**HIGH PEAK BOROUGH COUNCIL  
DEVELOPMENT CONTROL COMMITTEE**

**ADDENDUM**

<b>Application No:</b>	HPK/2021/0216	
<b>Location</b>	Forge Bleach Works, Forge Road, Chinley	
<b>Proposal</b>	Reserved Matters application (revised) with details of the appearance, landscaping, layout and scale for Phase 2 of the residential development comprising of 62 dwellings and associated works pursuant to planning appeal reference APP/H1033/A/13/21898819 (HPK/2012/0312).	
<b>Applicant</b>	Innovation Forge Ltd	
<b>Agent</b>	Wain Homes (North West) Ltd	
<b>Parish/ward</b>	Chinley	<b>Date registered</b> 13 <sup>th</sup> April 2021
<b>If you have a question about this report please contact:</b> Rachael Simpkin <i>rachael.simpkin@highpeak.gov.uk 01538 395400 ext. 4122</i>

#### HPK/2021/0216 (Proposed Amendment)

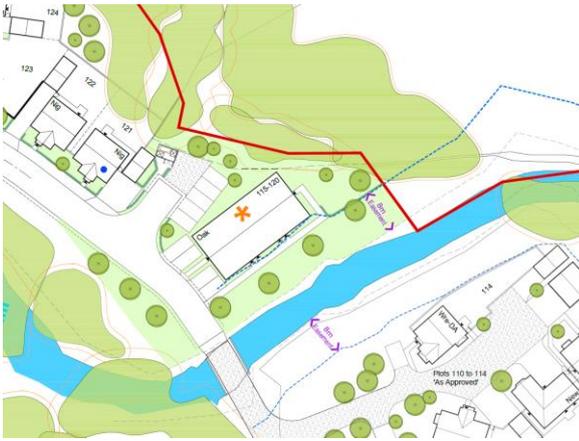
3.2 The applicant seeks a s.73 planning permission in relation to ref. HPK/2016/0313 to reposition the Oakmere apartment block (Plots 115 – 120) with the reconfiguring of the associated six car parking spaces and bin store. The elevation treatment and floorplans of the Oakmere apartments have been reconfigured. As well, a modest amendment to the position of the garage serving Plot 121 is also sought. The submission is accompanied by an updated flood risk assessment and amended landscaping scheme.

3.3 The applicant outlines that the amendments are sought on the basis of the incorrect plotting of the Black Brook water course at the far eastern part of the site (the remaining part of the site to be redeveloped), as the original topographical survey was not representative of the onsite position. As a consequence, this discrepancy would have

significant implications for the maintenance of an 8.0 metre easement to the north of Black Brook (as required by the Environment Agency) in the approved scheme.
